RAD PROPERTY No. 173-2
 APPN. No. 18370-173-2
 6298

RE : PROPOSED DWELLING LOT 1 LAKE FERRY ROAD.

EVAPOTRANSPIRATION SYSTEM - Standard Plan

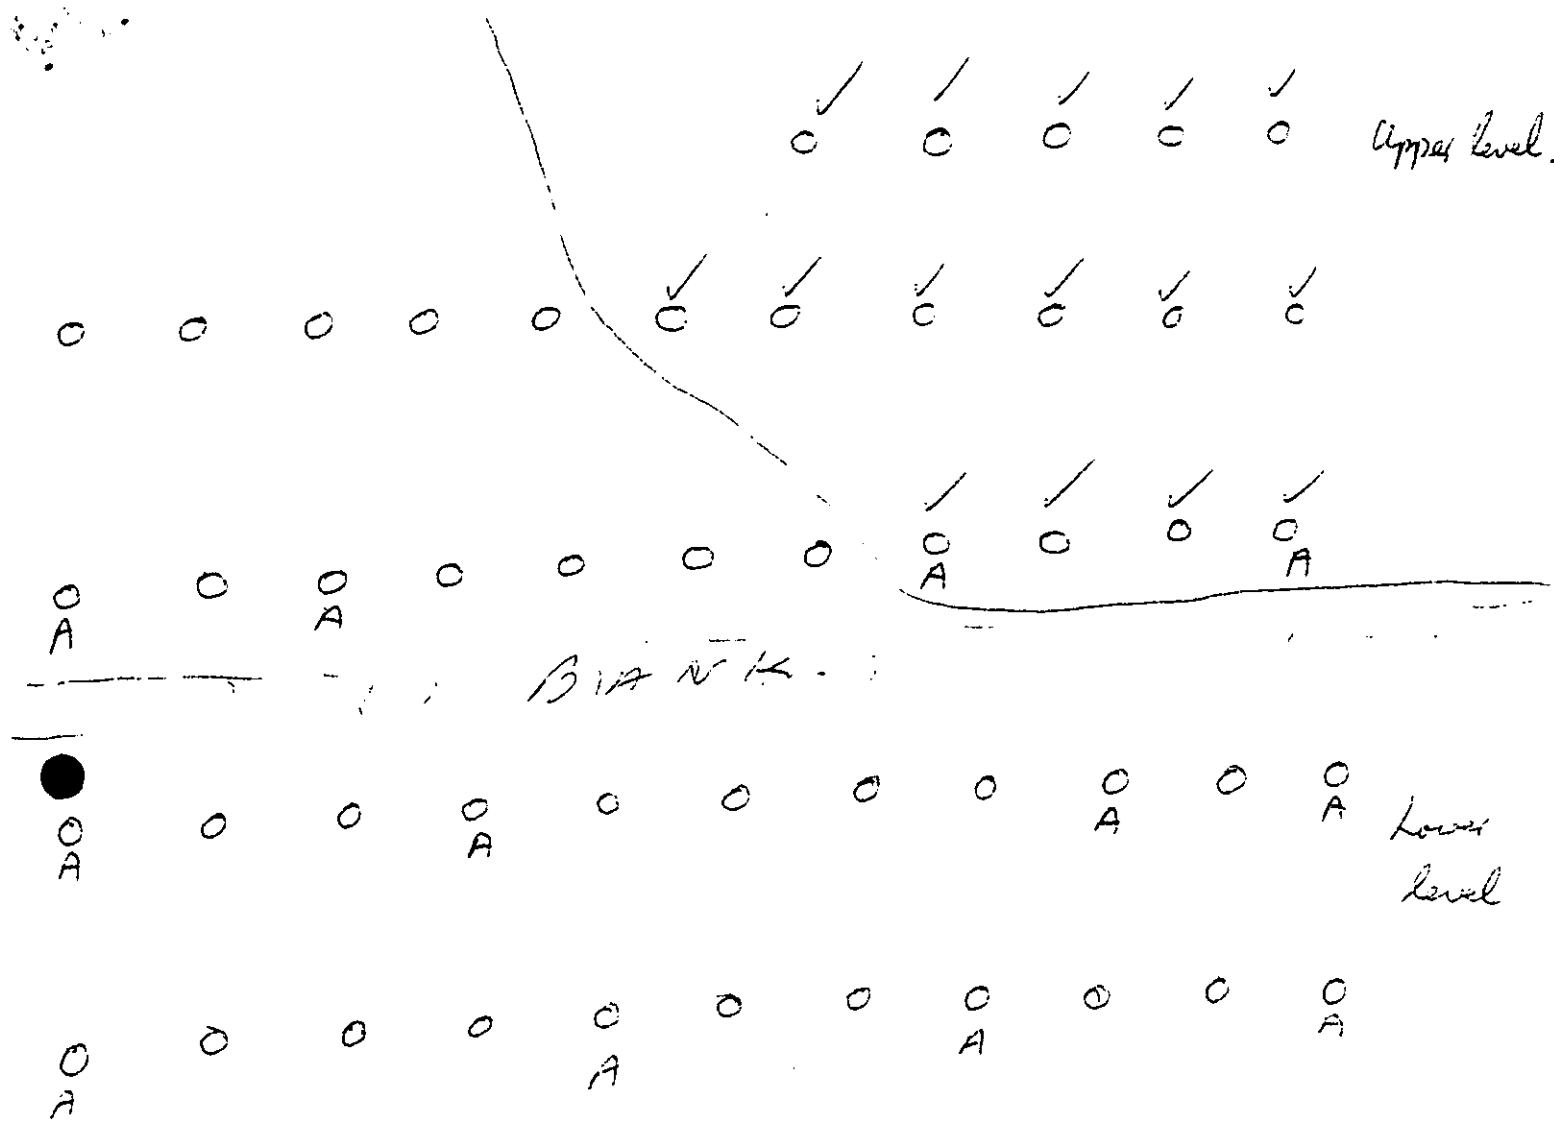
24/12/92

Pile holes above Red line satisfactory.

Pile holes below red line are dug into uncompacted fill and are Not satisfactory. No concreting permitted until all these holes are approved.

- 1 All pile holes to be dug out thru' the fill and into original clay.
- 2 All pile holes to be 12 inches square on the bottom of holes.
- 3 Bottom of all holes to be dead flat and all loose spoil removed before any concrete.
- 4 All pile holes shown with a tick (✓) are OK. All other piles to be dug out as in 1 above.

PLAN

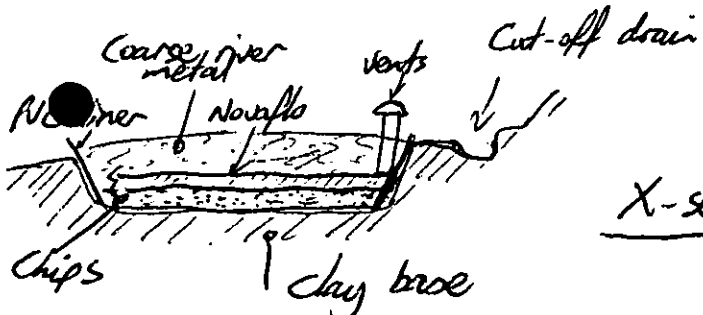
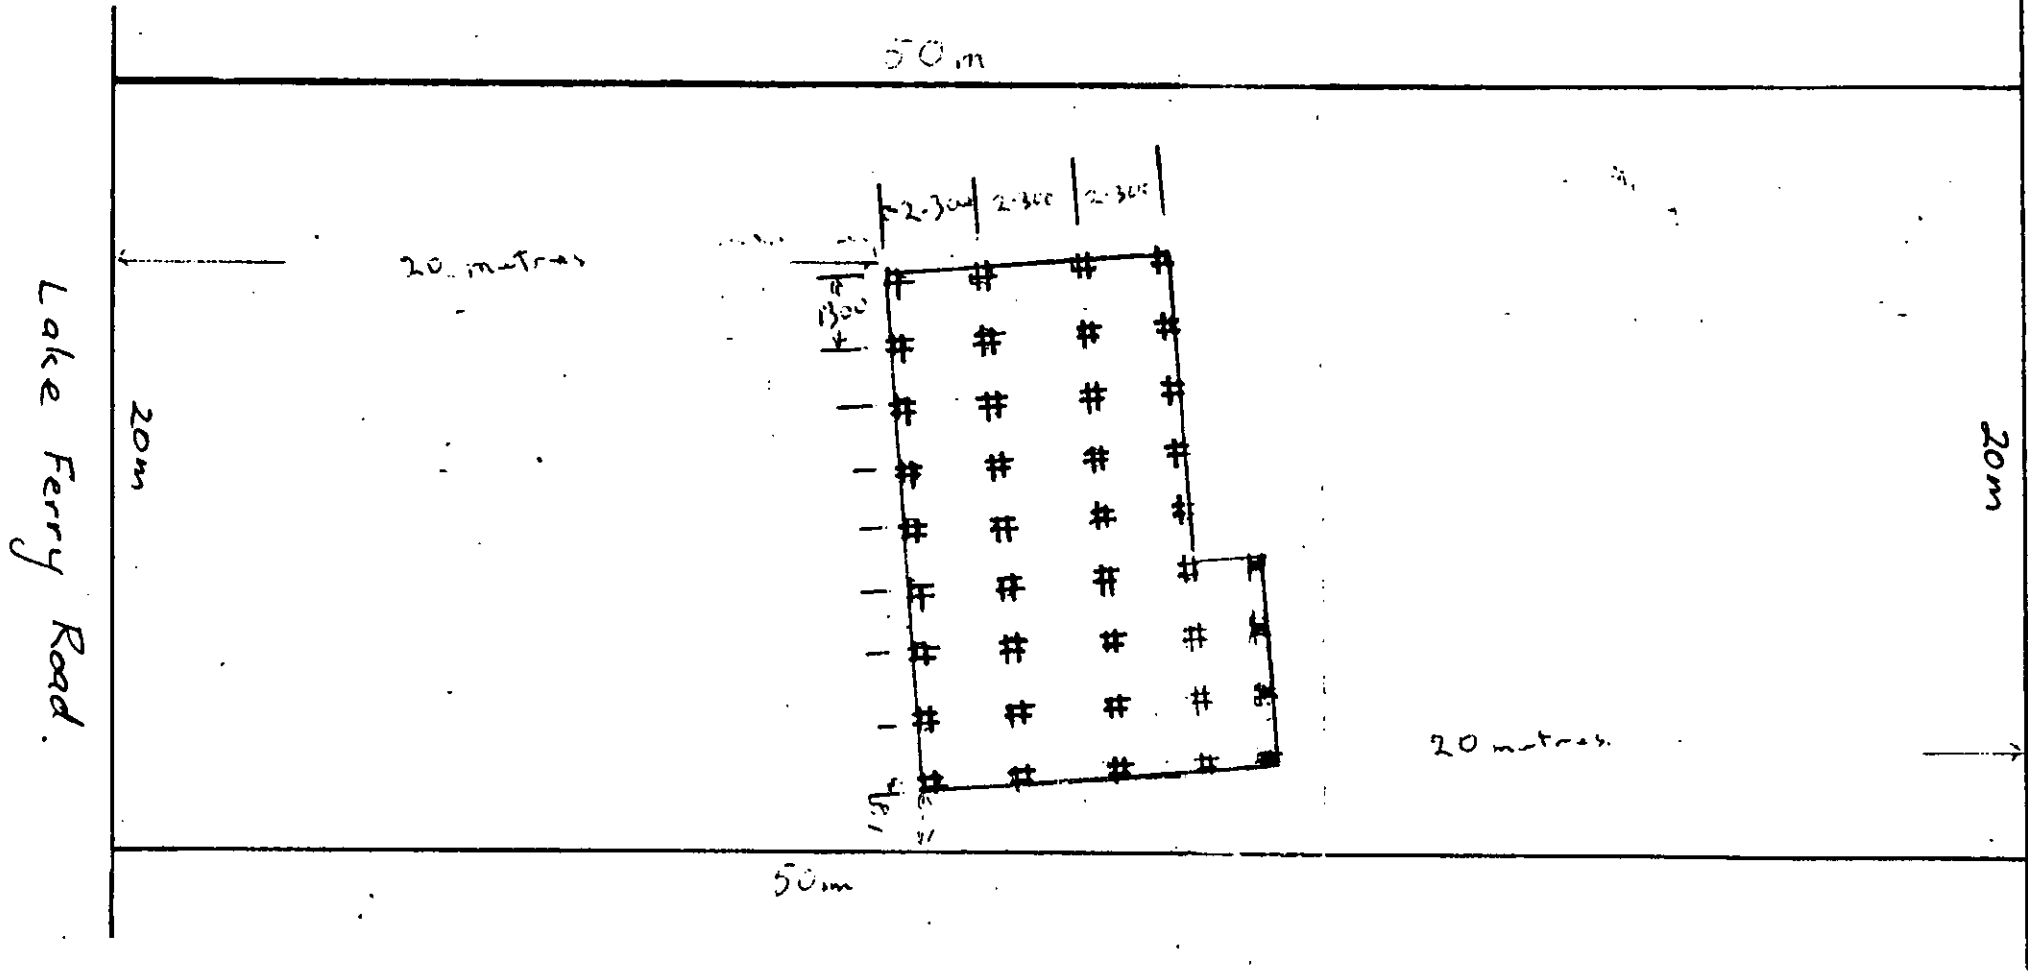
Subject: Mellish evapotranspiration bed - Lake Ferry File:
Your Letter: 15.12.92 Reference: Inspection

Construction of the bed was as per the plan. When I inspected the site progress was: - PVC liner, base layer of chips, Novaflo pipes all installed. Backfilling over Novaflo was progressing - a coarse river metal was being used (screened ex. Turanganui River)
